## Los Alamos County

### PLANNING & ZONING COMMISSION STAFF REPORT

**Subject:** Case No. SIT-2020-0046

A request for site plan approval for a financial institution at 1010 Central Avenue, located in the Eastern Area 2 Subdivision, Lot EA2 2. The proposed development will consist of a new credit union building, with associated on-site parking and traffic circulation, on 0.60± acres of land zoned Downtown district-Town center overlay zone (DT-TCO), as shown in Exhibit A below.

PROJ. NO:		2019-955	
ISSUE DATE:		6.22.20	
ISSUED FOR:		LOS ALAMOS COUNTY REVIEW	
REVISIONS:			
NO	Date	Description	
DRAFTED BY: JDC			
APPROVED BY: DJP			
SCALE: As indicated			
PROPOSED ARCHITECTURAL SITE PLAN			
AS101

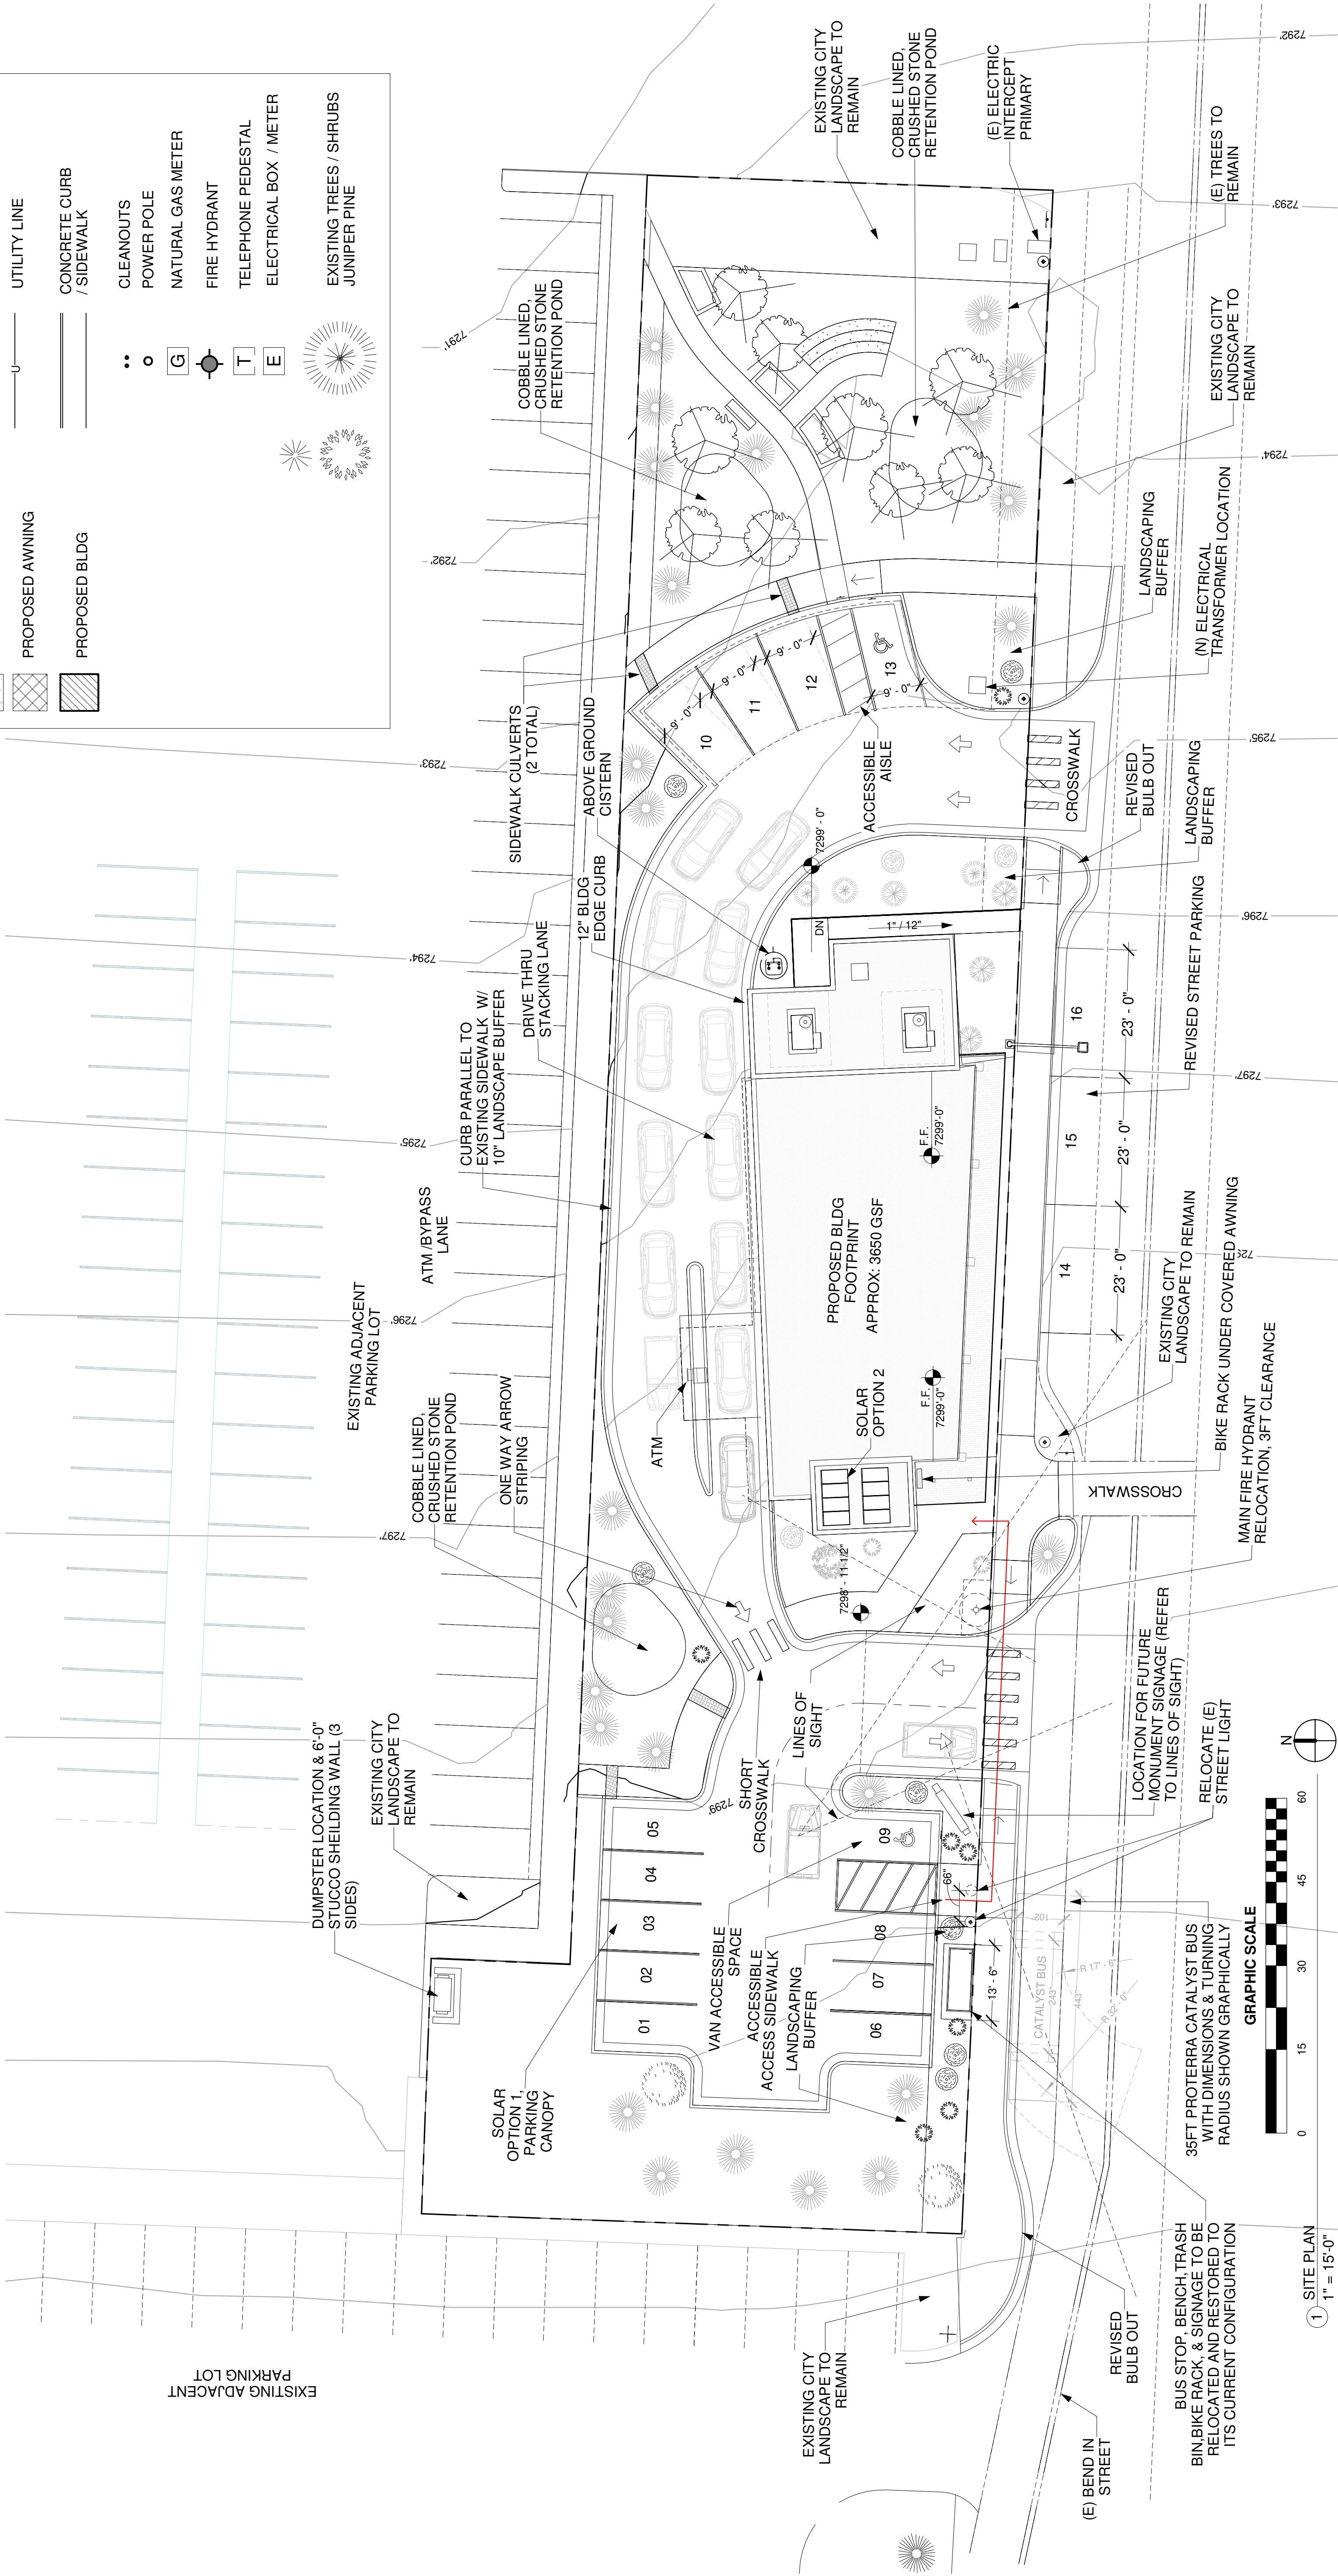
1. Per County Engineer, Public Works: Monument sign proposed shall not obstruct sight distance and visibility for exiting vehicles.
2. Per County Engineer, Public Works: Driveway construction details shall be addressed in the construction drawings submitted for building permit. Also note:

3. Per Public Works, Streets Division: A comment regarding the placement of the last parking space (#14 on the site plan) being too close to the eastern entrance. Perhaps this could be moved next to parking space 5, if needed.

4. Per Public Works, Streets Division: Provide a sidewalk connection from the eastern parking area through the landscape buffer, to the building. Especially if the only ADA space is in the eastern parking area.

5. Per Public Works, Streets Division: Perhaps the 3ft. space next to the ADA space can be swapped to get it farther from the driveway entrance.
6. Per Department of Public Utilities: The utility plan does not show the electric service. This needs to be added to the utility plan. See attached comments from prior submittal regarding electric service connection.

# **EXHIBIT “F”**

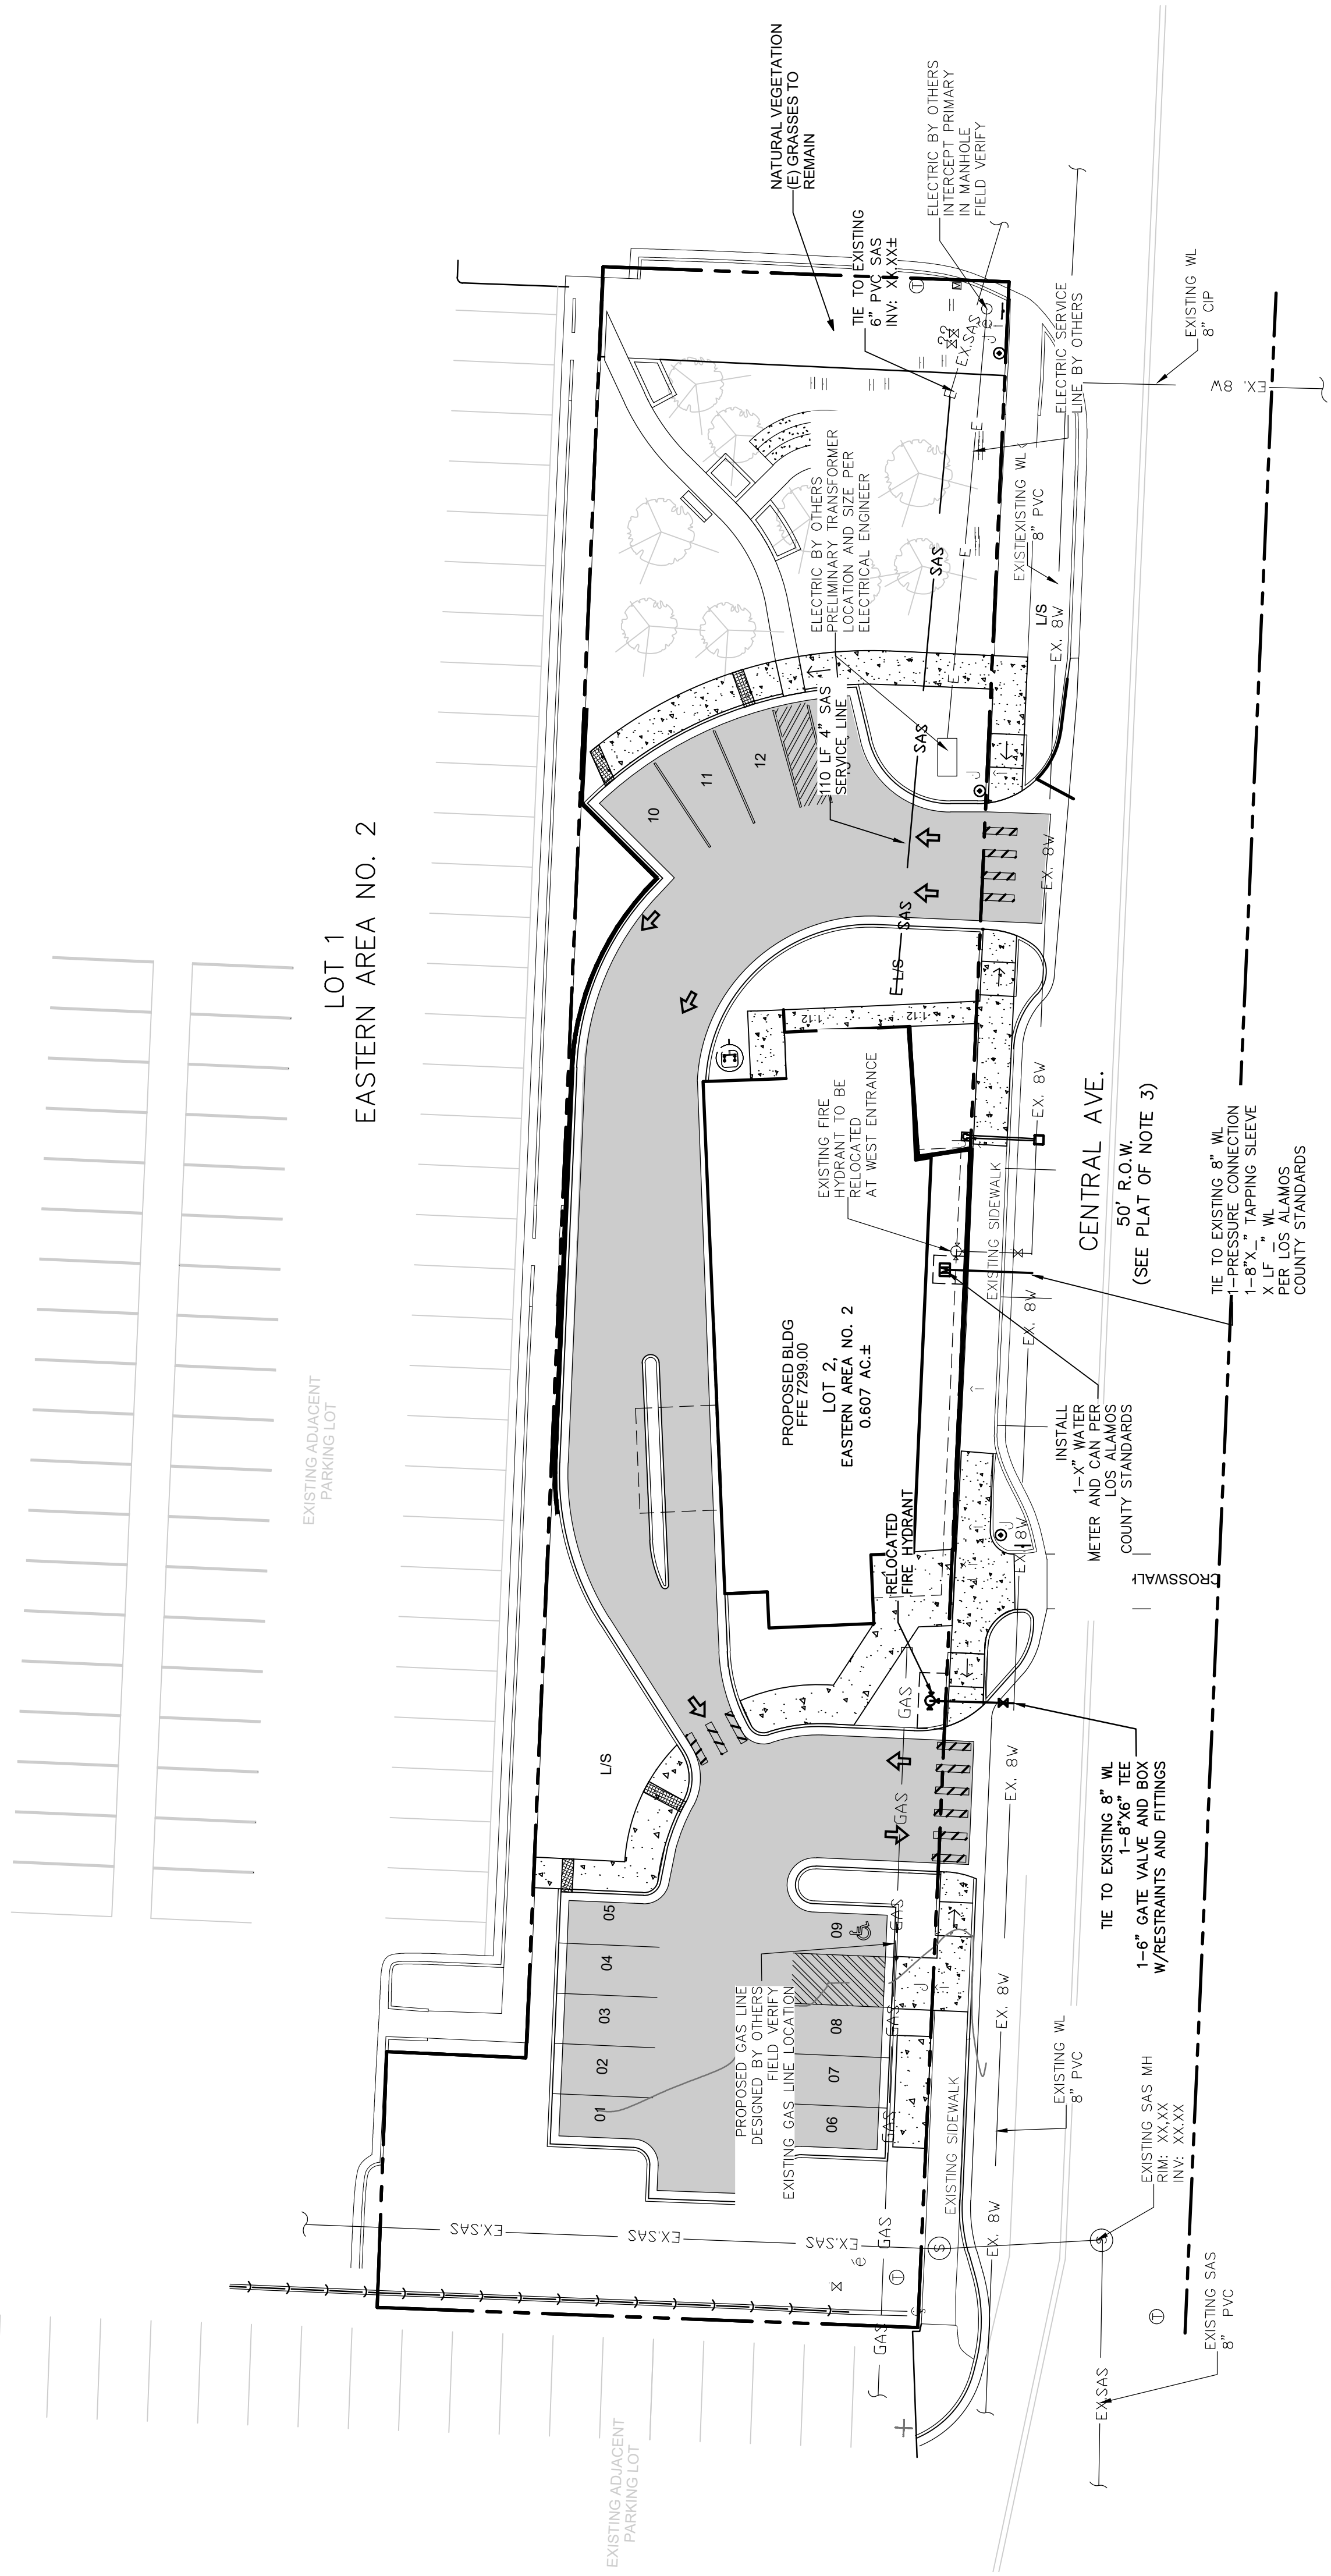
- Comment #6 Per Department of Public Utilities: The utility plan does not show the electric service. This needs to be added to the utility plan. See attached comments from prior submittal regarding electric service connection.

Staff Response: Detailed drawings of water, sanitary sewer, electrical, gas, storm sewer will demonstrate conformance prior to submittal of building permits should the Planning & Zoning Commission approve the site plan. A comment by the Interdepartmental Review Committee (IDRC) has been met in order to meet these criteria:
